Access Compliance Report Public Rights-of-Way (Curb Ramps)

Intersection ID: 11835 Main Street: BELMONT AV Cross Street: N DAVIDSON ST Location: Ε **Overall Compliance: No Severity Score:** 10 ADA ID: 13683DB4244E Ramp Type: BlendTrans2 Initial Pass/Fail: Fail

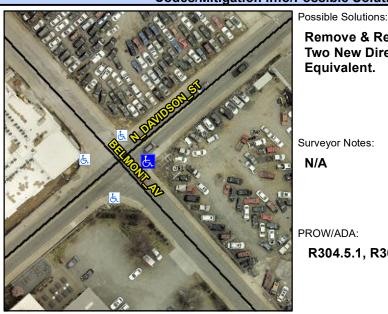
R304.5.1, R304.5.3

Compliance Description Data Compliance Description Data Yes N/A Ramp Length (in) 47.0 BlendTrans Slope (%) 1.6 38.0 No No Ramp Width (in) BlendTrans XSlope (%) 3.0 N/A N/A Flare Type LT N/A Flare Type RT N/A N/A Flare Slope LT (%) N/A N/A Flare Slope RT (%) N/A N/A Flare Traversable LT? N/A N/A Flare Traversable RT? N/A N/A Landing Length (in) N/A N/A **DWS Provided?** N/A N/A Landing Width (in) N/A N/A **DWS Contrast?** N/A N/A N/A N/A Landing Slope (%) DWS Length (in) N/A N/A Landing X Slope (%) N/A N/A DWS Full Width? N/A N/A Landing Curb? (Y/N) N/A N/A DWS Offset (in) N/A N/A N/A Shared Landing? N/A **Gutter Ponding?** N/A N/A Gutter Slope (%) N/A N/A Gutter Lip Ht (in) N/A N/A Gutter X Slope (%) N/A N/A Painted X Walk1? No N/A Painted X Walk2? No X Walk 1 Direction To NW X Walk 2 Direction To SW N/A X Walk 1 Width (in) X Walk 2 Width (in) N/A X Walk 1 Slope (%) X Walk 2 Slope (%) 2.5 3.1 X Walk 1 X Slope (%) 2.7 X Walk 2 X Slope (%) 1.4 N/A N/A Ramp inside XWalk2? N/A N/A Ramp inside XWalk1? Road Slope (%) 0.9 Clear Space? N/A Road X Slope (%) 2.3 N/A Clear Space to XWalk (in) N/A N/A N/A N/A Any Obstructions? Storm Grate/Utility Hazard? N/A **Obstruction Type** Storm Grate/Utility Type N/A N/A Yes Surface Condition? (G/P) Good N/A Curb Slope (%) 3.9

Remove & Replace Curb Ramp With Two New Directional Ramps or Equivalent.
